Project	IEEE 802.16 Broadband Wireless Access Working Group < http://ieee802.org/16 >	
Title	802.16g Protocol Architecture Model	
Date Submitted	2005-03-11	
Source(s)	<p>Jose Puthenkulam, Sanjay Bakshi, Bala Rajagopalan, Prakash Iyer Intel Corporation</p> <p>Torsten Fahldieck Alcatel</p> <p>Nat Natarajan Motorola Inc.</p>	<p>Voice: (503) 264 6121 Email: jose.p.puthenkulam@intel.com</p> <p>Voice: +49.711.821 -32163 Email: torsten.fahldieck@alcatel.de</p> <p>Voice: (847)-632-6303 Email: Nat.Natarajan@motorola.com</p>
Re:	Call for comments	
Abstract		
Purpose	This document proposes a 802.16g protocol architecture model	
Notice	This document has been prepared to assist IEEE 802.16. It is offered as a basis for discussion and is not binding on the contributing individual(s) or organization(s). The material in this document is subject to change in form and content after further study. The contributor(s) reserve(s) the right to add, amend or withdraw material contained herein.

802.16g Protocol Architectural Model

Current 802.16e Network Reference Model

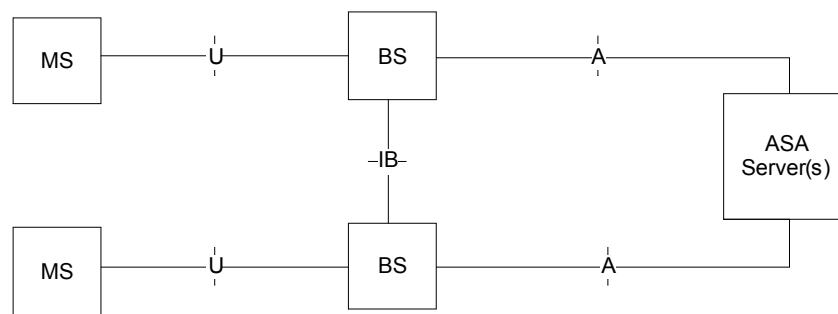
Some observations:

- This model probably over simplifies the network mobility problem by only depicting the Authentication and Service Authorization Servers interfacing to the BSes over the backbone network.
- Layer 3+ protocol entities that possibly assist mobility over the air interface are not depicted.
- AAA functions are expected to be implemented over the A interface by ASA servers, the details of which are not specified.
- This model proposes an IB interface between BS for the purposes of HO. The details of IB interface are not specified. However implicit reference to the IB interface between the Serving BS and the Target BS is assumed when HO flow messages are described (Annex C of [1]).
- It does not describe any specific interface at the MAC layer for upper layer control plane or management plane protocols to utilize.

Current 802.16g Network Reference Model

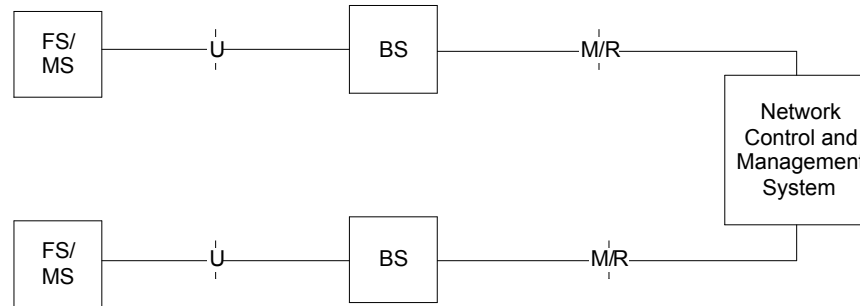
- This model also simplifies the network reference model by depicting a Network Control and Management System (NCMS) abstraction behind the BS.
- The U interface is defined for management and control over the air interface.

- The M/R interface addresses Management (M) and Radio Control (R) aspects of the BS and FS/MS by the NCMS. However the NCMS is an abstraction with the intent to abstract the network and all L3+ upper layer interfaces in a network topology agnostic manner.

- As L3+ protocol definitions are outside scope of P802.16g, the specific entities the BS communicates with at L3 are not visible at MAC layer, but they are assumed to be within the NCMS abstraction. L3+ protocols still rely on the MAC Layer (L2) primitives for their proper function. M/R interfaces

- However as all BS will implement L3+ protocols and the M/R interface could essentially be subsumed into the BS protocol stack, and then the figure could be misinterpreted for M/R implying yet another protocol link layer, while it really is a inter-layer protocol interface. So some clarification is needed to make this distinct.

Figure x - 802.16g SAP interfaces within the BS

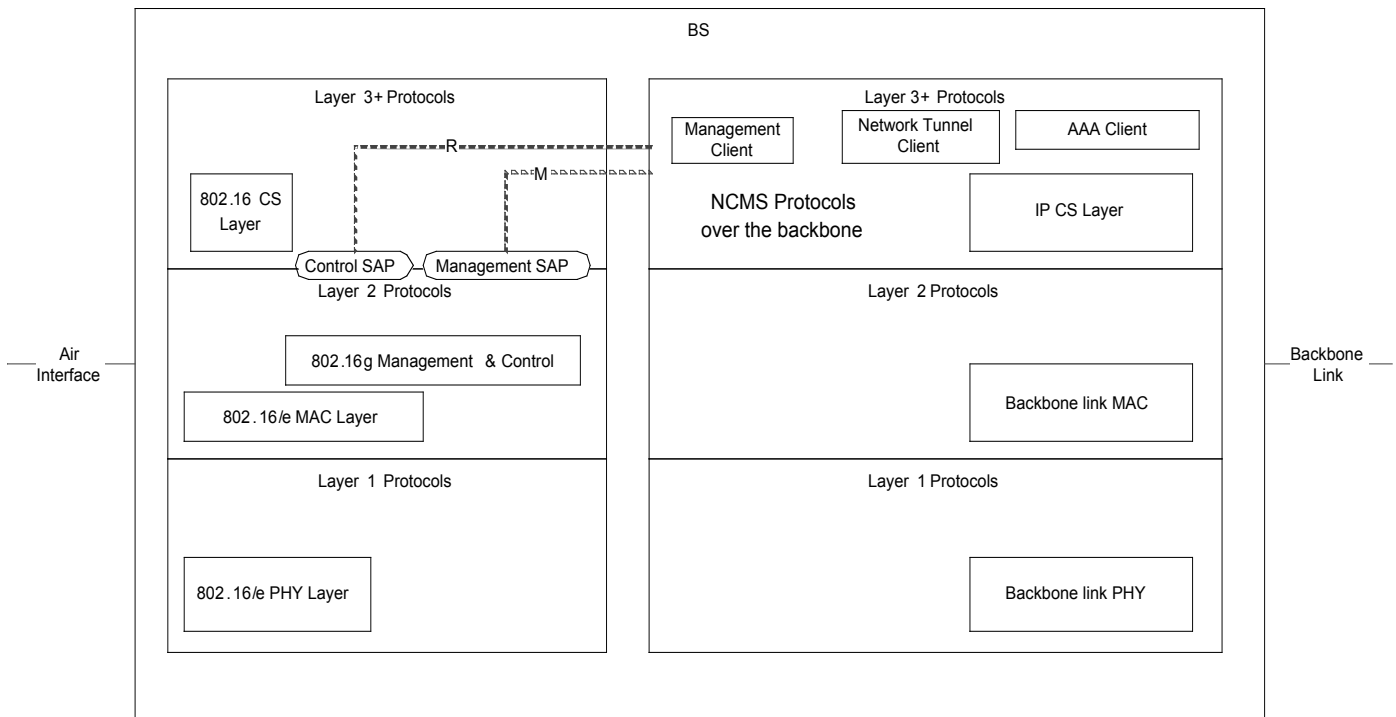
The figure below proposes Control and Management SAPs for interfacing 802.16g to the control and management planes of the NCMS abstraction.

The control and management SAP are used for mapping to NCMS protocols over the backbone link. These SAPs provide the minimal primitives by which the L3+ protocols used within the NCMS will be able to invoke any 802.16 MAC control or management plane protocol exchanges over the air interface. 802.16g should also define MAC Layer (L2) context info for use by L3+ protocol specifications in a network agnostic manner.

This should also clarify the P802.16g will not define network protocol messages between BSeS and also between BSeS and NCMS internal entities as they would be out of scope. Also 802.16g will not define any SAPs for the data/bearer plane protocol aspects.

802.16g Network Reference Model

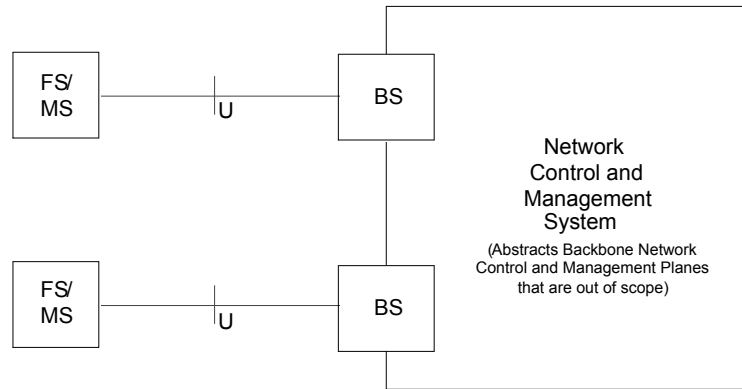
[Insert the following figure into section identified]

Figure x - Illustration of 802.16 g SAP interfaces within the BS

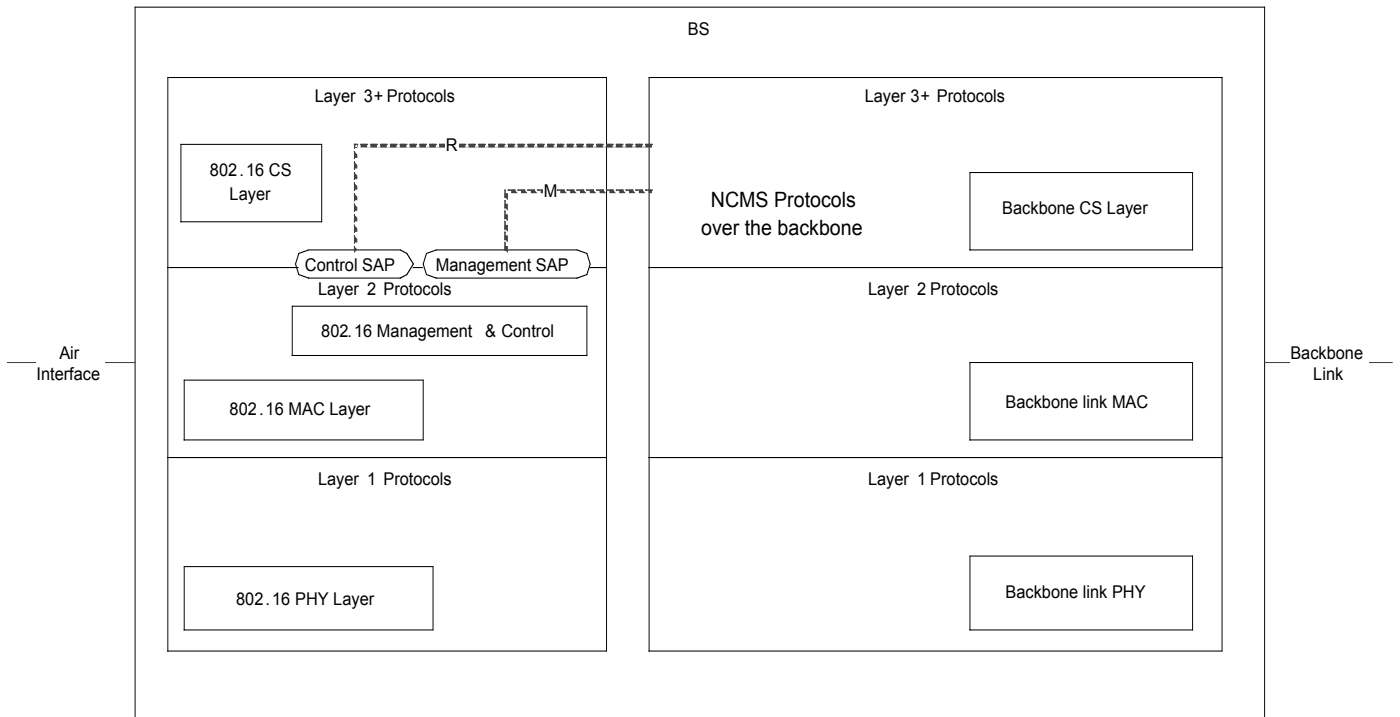
This interface is a functional one and exists above the MAC layer and typically exists within a BS as shown in Figure x below. It is decomposed in to two parts: the M interface used for Management primitives alone and the R (Radio Control) interface used for Control plane primitives that to support handovers, security context management, radio resource management, and low power operations (such as Idle mode and paging functions). The primary goal of such an interface is to ensure protocol separation.
